Amendment 11 to CoC 1004 RAI # 2

***TN-NRC Meeting
June 25, 2009***

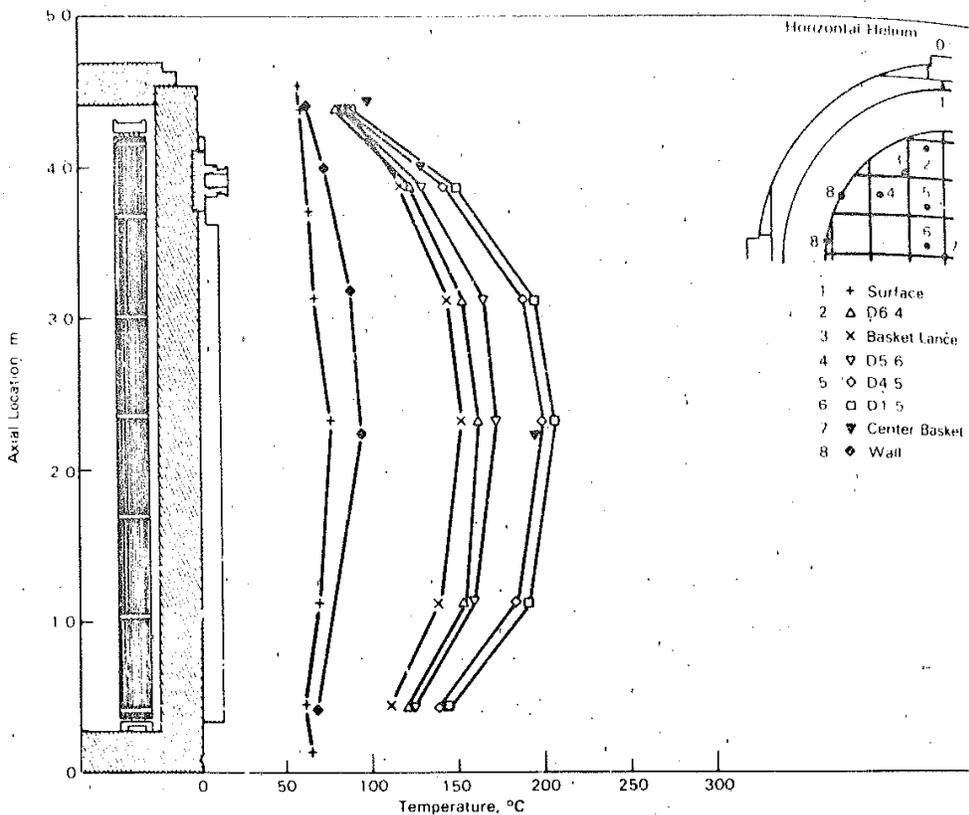
- 3.1 Justify that the assumption of a uniform heat flux at the transfer cask outer shell is a conservative representation of DSC/TC system within the supplemental shielding, and demonstrate that it can produce a conservative estimate of the temperature distribution on the transfer cask outer shell.

In the FLUENT model of the OS197L on the transfer skid enclosed with the supplemental shielding, the assumption of a uniform heat flux at the transfer cask outer shell is a significant simplification in the boundary conditions. It does not account for the variation in heat transfer on the transfer cask shell, due to variation in the surface heat transfer coefficient around the circumference of a horizontal cylinder. It also assumes that the heat flux is uniform along the entire 183.85-inch axial length of the neutron shield, as well as around the circumference of the 40.18-inch diameter neutron shield. (Note that this temperature distribution provides boundary conditions for the next step in the analysis, using a 2D ANSYS model of the OS197L transfer cask.)

The justification for using a uniform heat flux at the transfer cask outer shell for determining the temperature distribution on the transfer cask’s outer shell within the auxiliary shielding is based on a combination of prior safety analyses and the result of physical testing. The following paragraphs describe the relevancy of each of these justifications.

Physical Testing: The use of a uniform decay heat flux is also validated by physical test data. For example, Figure 4-14 in the report, “The TN-24P PWR Spent-Fuel Storage Cask: Testing and Analyses,” EPRI, EPRI-NP—5128, (PNL-6054), 1987, illustrates the measured temperatures on a horizontal TN-24P cask with a helium backfill. As seen, while the axial variation in the measured fuel cladding temperature clearly shows the effect of the decay heat peaking factor, the axial variation in temperature is largely not present for the temperature distribution at the edge of the basket (i.e., T/C #8) and is barely noticeable for the temperature distribution along the outer edge of the cask body (i.e., T/C #1). These results clearly demonstrate that the use of a uniform decay heat flux along the outer wall of the cask, especially if combined with end effects, would yield the same nearly uniform cask surface temperatures with a slight fall off at the ends as seen in the actual testing. Thus, the validity of using a uniform heat flux to support the calculation of the temperature distribution on the cask is supported by test data.

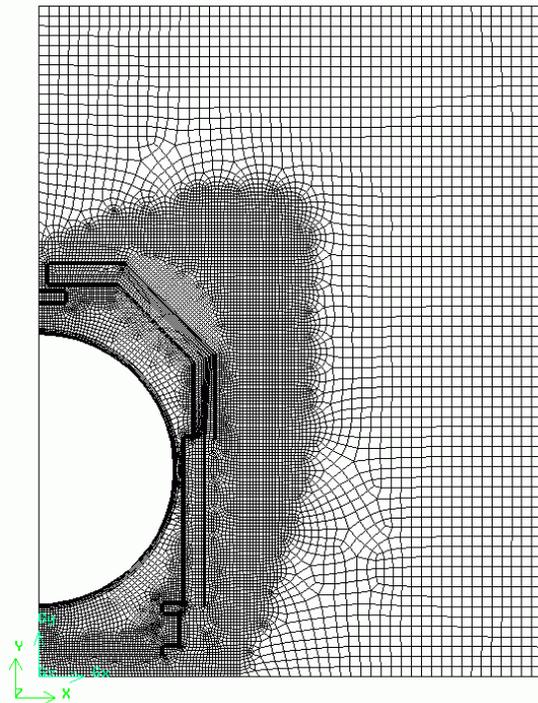
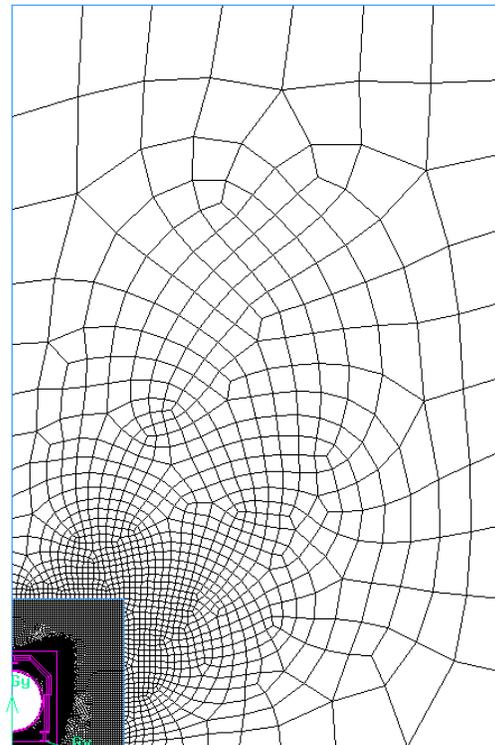
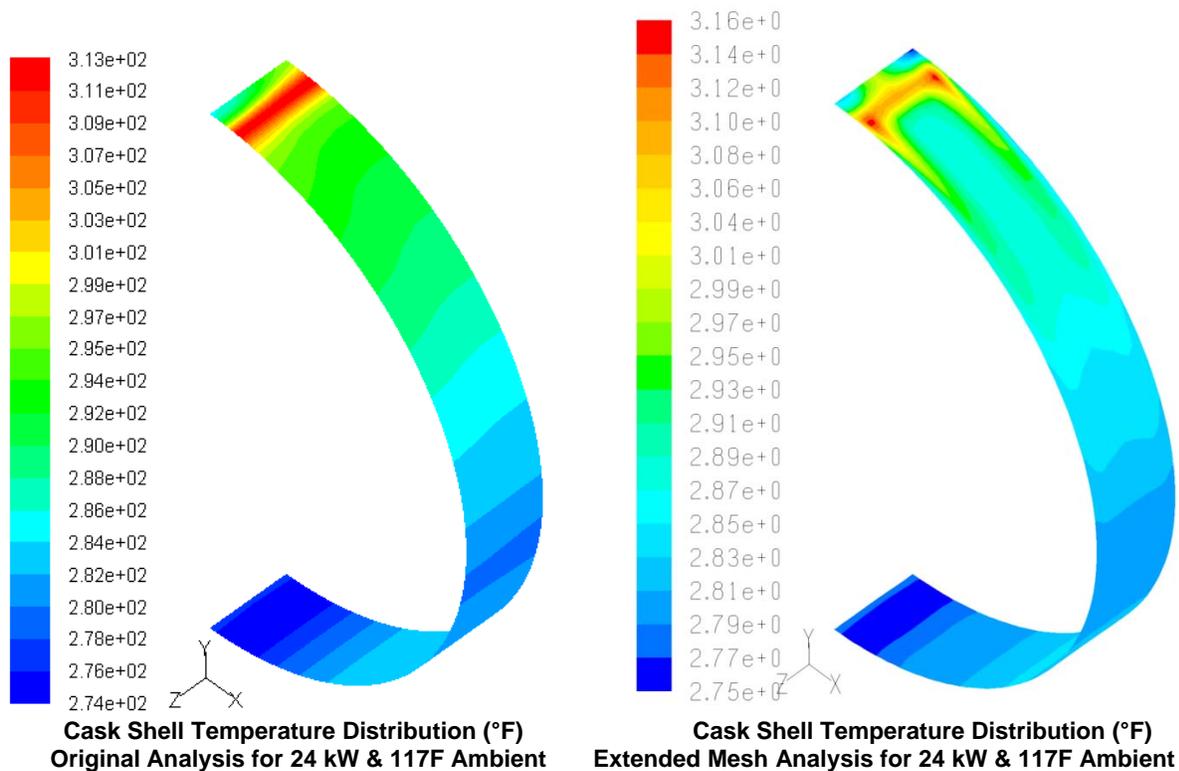
The size of the exterior fluid mesh in the FLUENT model of the OS197L transfer cask within the supplemental shielding may not be sufficient to extend to true ambient temperature. The mesh extends only about 1.5 to 2 IJD beyond the outer surface of the supplemental shielding into the surrounding air. Typically, the transition length is on the order of 5 to 10 L/D for thermal and velocity gradients in an infinite medium. The effect of truncating the distance to ambient would be non-conservative; it would overstate the steepness of the temperature gradient to ambient, resulting in a higher heat transfer rate than can actually be obtained.

By definition, the thickness of a thermal boundary layer is measured by the distance from the surface to the point at which the flow temperature is within 99% of the free stream temperature. Since the boundary layer thickness on the auxiliary shielding will not be more than a few inches thick at most (based on logic, hand calcs, etc), the 'steepness' of the temperature gradient is not over stated by the positioning of the ambient boundaries 75 to 100 inches away, as used in the CFD modeling. What can be affected by the proximity of the ambient boundary are the velocity and pressure profiles, which in turn have an impact on the boundary layer calculation. However, given the relatively low flow velocities and delta pressures associated with this case, the effect on the computed surface temperature was expected to be only minor and it was expected that these effects would diminish in proportion to the separation distance between the ambient boundary and the auxiliary shield wall. As such, no significant impact was expected by the selection of the ambient boundary positioning used in the modeling. To verify this conclusion, a sensitivity analysis was conducted using an extended computational mesh which extends the ambient boundaries from 150 to 660 inches in the x-direction and from 200 to 1,000 inches in the y-

It was noted that the extended mesh setup has more difficulty in achieving a steady-state solution at the top of the cask shell in terms of a symmetric temperature distribution pattern along the z-axis. After numerous runs with variations in the under relaxation factors, pressure-velocity coupling method, and extended consultation with FLUENT technical support, it was concluded that the turbulent nature of the heat transfer at this portion of the cask shell was the root cause of the non-symmetry. This conclusion is supported by the fact that extending the number of iterations yielded a cyclic repetition in the temperature distribution pattern, but with little change in the resultant peak, minimum, and average cask shell temperature between iterations. While exercising the model in a transient mode and averaging the temperature results could be used to yield a time-averaged solution, the added effort was deemed not necessary for the purpose of addressing the sensitivity of the solution to the placement of the ambient boundary condition.

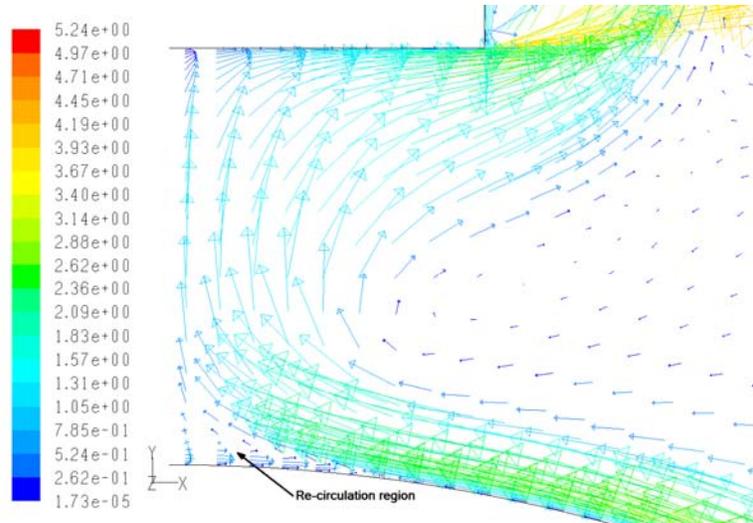
- 3.4 Justify that the analysis results presented in Figures W.4-5 and W.4-9 result from a conservative representation of DSC/TC system within the supplemental shielding, and demonstrate that this is a conservative estimate of the temperature distribution on the transfer cask outer shell.

The temperature graphics in Figures W.4-5 and W.4-9 show an off-set peak temperature location on the TC outer shell that does not appear to be consistent with natural convective heat transfer or with the flow field velocity vectors shown in Figures W.4-7 and W.4-8. (Note that this temperature distribution provides boundary conditions for the next step in the analysis, using a 2D ANSYS model of the OS197L transfer cask.)

point of flow stagnation and the centerline of the cask. A close examination of Figure W.4-8 will show the presence of this recirculation zone, although the scale of the figure makes it difficult. An enlarged view of the velocity field in this region of the model presented below clearly demonstrates the presence of the recirculation flow at the top of the cask. Since it is the stagnation zone that experiences the highest surface temperature, the temperature distribution illustrated in Figures W.4-5 and W.4-9 correctly depicts the location of elevated shell temperature at the region of the cask shell where the circumferential flow stagnates and detaches.
